To: Saint Paul City Council
From: George Gause, Heritage Preservation Supervisor
Re: Appeal of HPC approval of ADU at 525 Holly

Re: Appeal on COA for an ADU at 525 Holly Ave

View through Holly park of house and existing garage in green. ADU will be taller, extended to left 5' and have deck over 9' off ground.

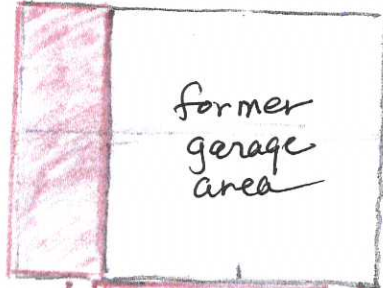
district. In addition to being fully visible (image) from Holly Avenue half of the year, the deck lacks required visual refinement, a condition which was reinforced by HPC's recommendation that deck glass panels be replaced by cable railing, neither of which is historic.

Visibility is measured from the sidewalk at the front of the property. The main and neighboring structure blocks most views to the rear. There is no requirement that the new structure be completely screened from the right-of-way. The HPC reviews if a new structure would have an adverse impact on the streetscape. In the case of the ADU at 525 Holly, they did not believe that there would be an impact.

525 HOLLY PROPOSED

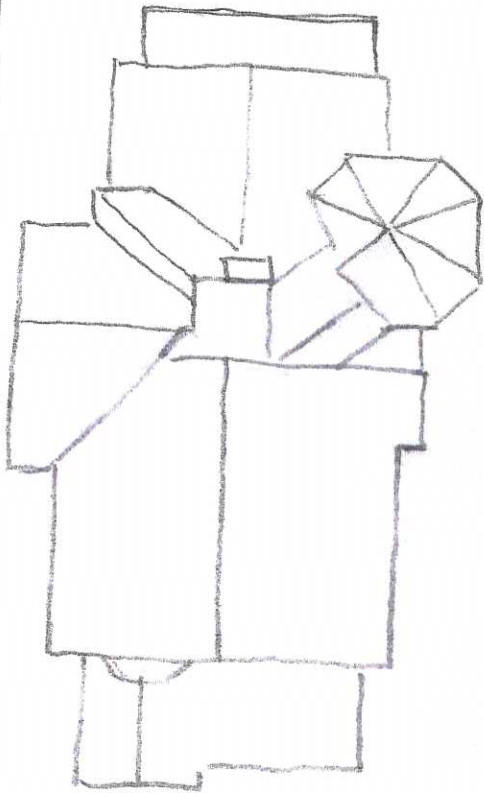
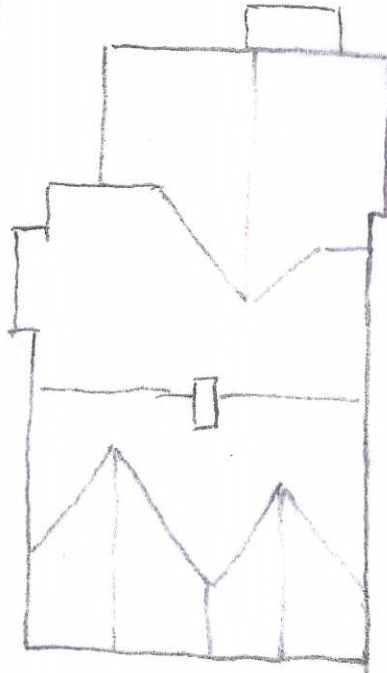
Pertaining to **Code Section 74.65b**, there was no mention or discussion that the proposed ADU's design totals an imposing 914 SF mass compared to the current structure's 576 SF. This is within the allowable SF back yard limit, but this 58.6% increase in 525's backyard physical infrastructure imposes on neighboring 529 Holly, which has three times less built structure in its backyard (see comparative illustration later).

The appellant has cited §74.65(b) Massing and Height. This section discusses 'residential structures' and gives an acceptable height range from 25 to 40 feet high. Clearly this was not intended for accessory structures. The massing and height are needed for the ADU. This area of the neighborhood contains several large, multi-stall accessory structures. The garage across the alley is 3 double stalls which is approximately 960 square feet in coverage. The ADU will add responsible density to this neighborhood and be in conformance with the Saint Paul Comprehensive Plan.
